ADDENDUM #1
ITB/RFP NUMBER: 2016038-PW-B
Mosby Road Sidewalk Project ITB

City of Harrisonburg's Mosby Road Sidewalk Project ITB, is modified as follows:

Location Map

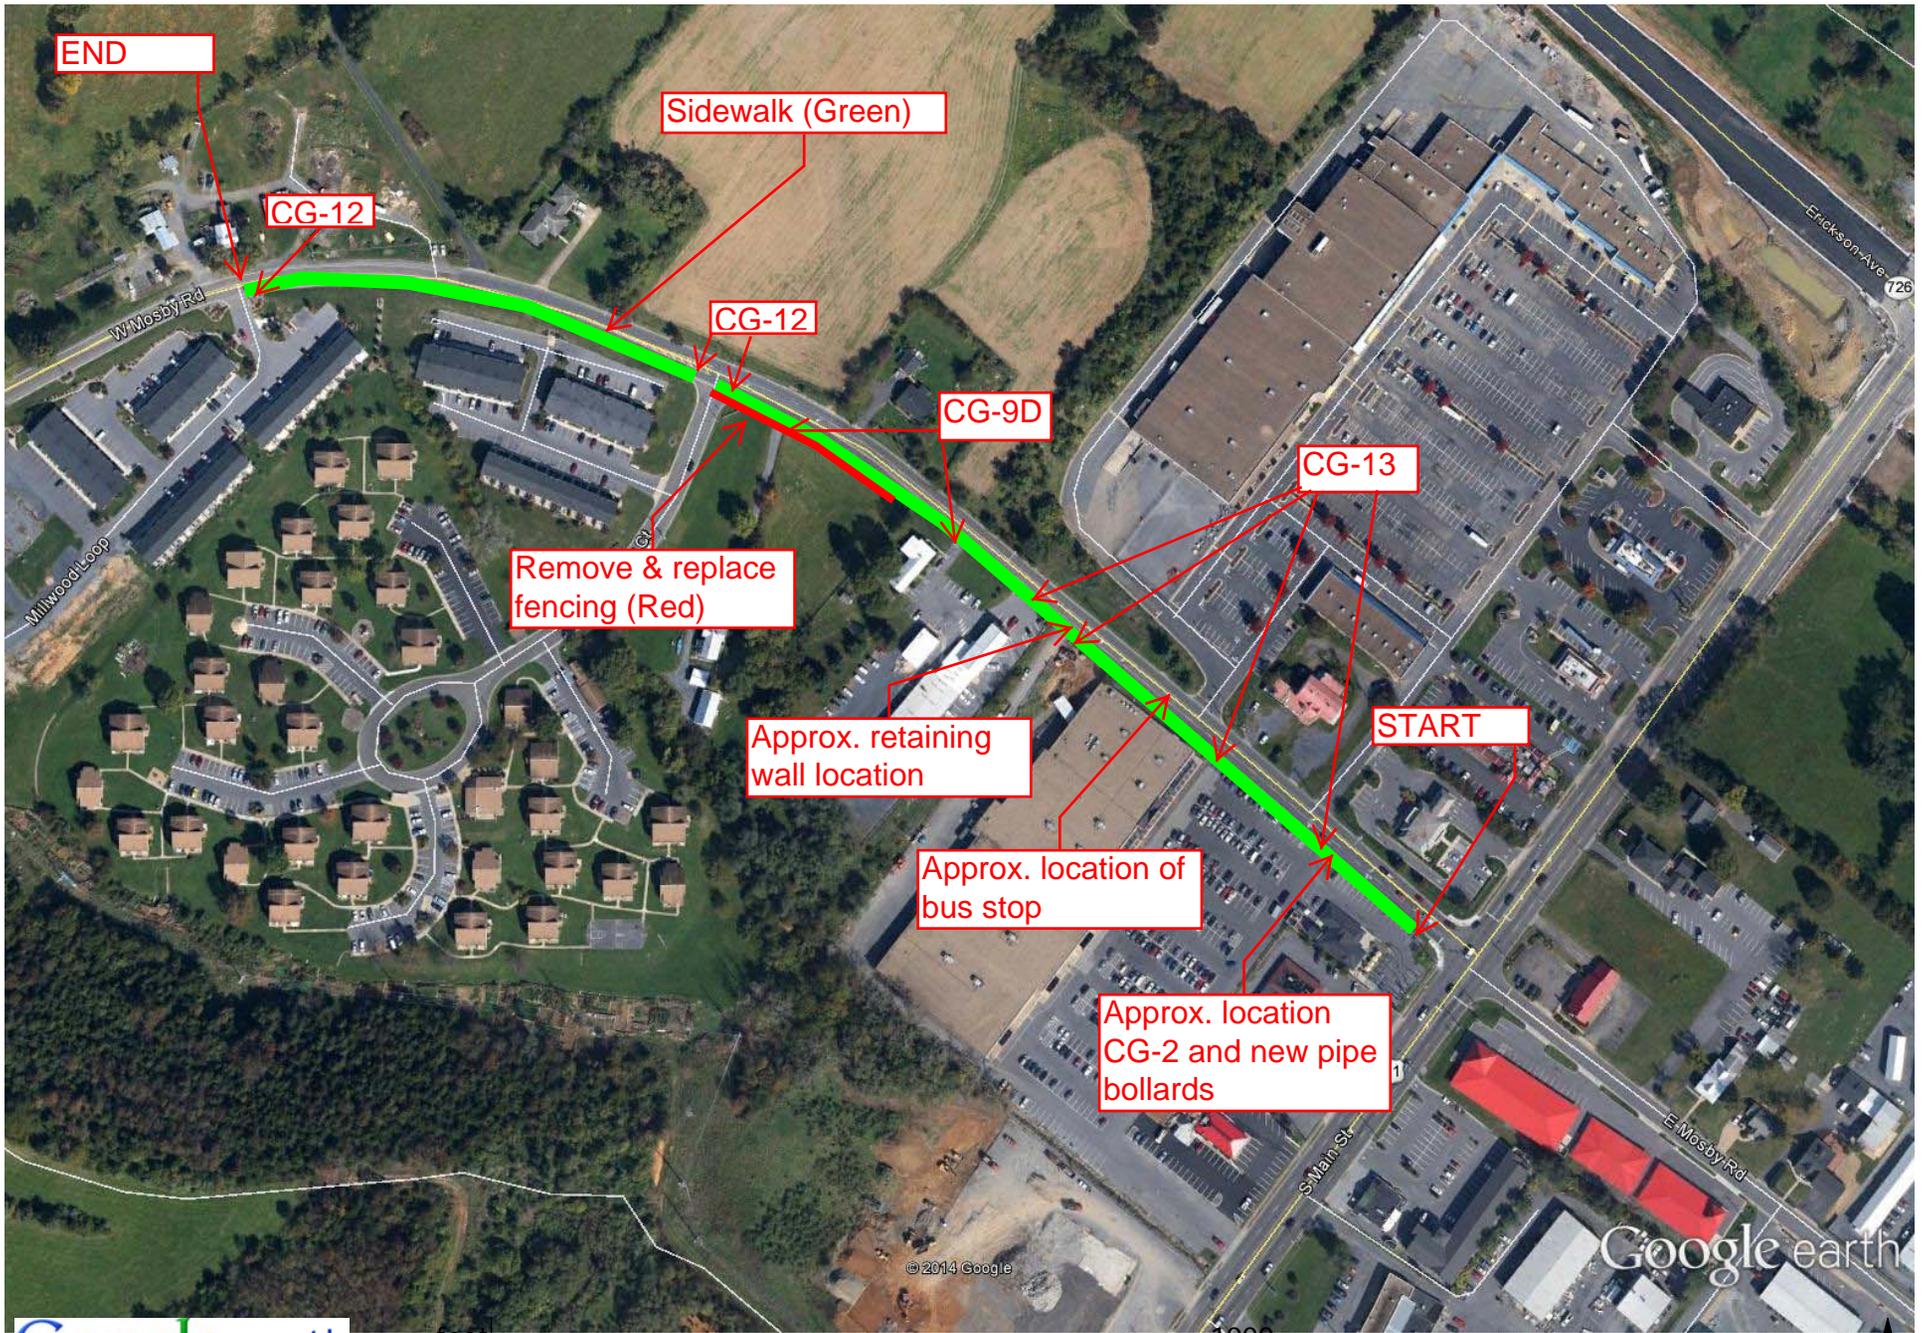
6. Please clarify the location of the CG-9D entrances.

8. Please clarify the location of the bus stop shelter.

9. Please clarify the location of the retaining wall.

10. A revised bid form with updated quantities is attached as part of this addendum (posted as a separate MS Excel document from this addendum). Note that CG-2 has been added as an item due to some of it being required adjacent to the sidewalk at the Sharp Shopper entrance closest to Main Street.

Answer: See attached map.

Answer: See attached map.

Answer: See Attached map.
